VERMONT YANKEE NUCLEAR POWER CORPORATION

October 30, 1998
BVY 98-153

Subject: Vermont Yankee Nuclear Power Station
License No. DPR-28 (Docket No. 50-271)
Response to NRC RAI Related To GL 96-06 Response

Response to Request for Additional Information Concerning GL 96-06

Simplified Reactor Building Closed Cooling Water System

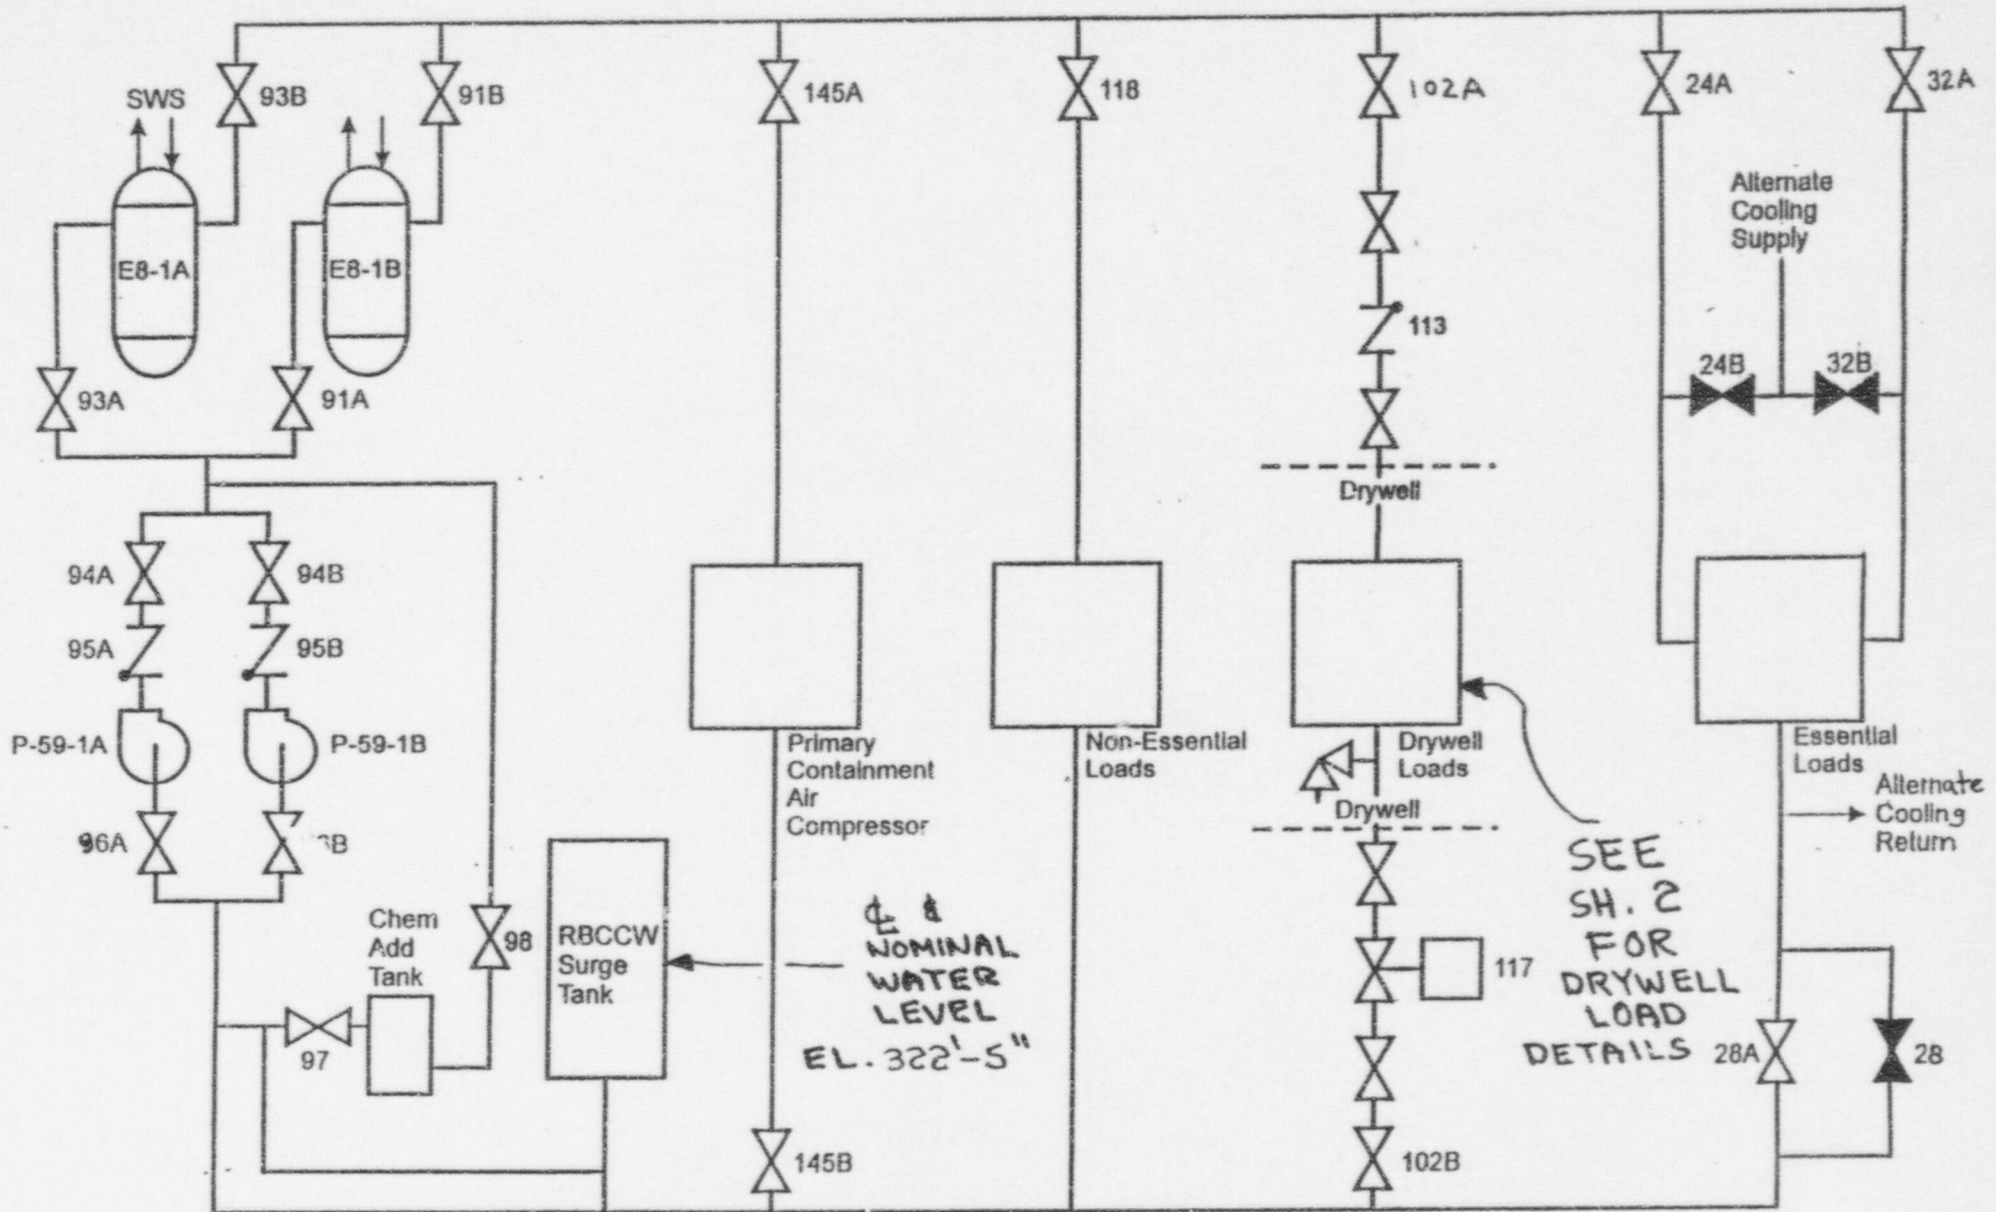
10. Provide a simplified diagram of the affected system, showing major components, active components, relative elevations, lengths of piping runs, and the location of any orifices and flow restrictions.

A simplified diagram is included as Attachment 2.
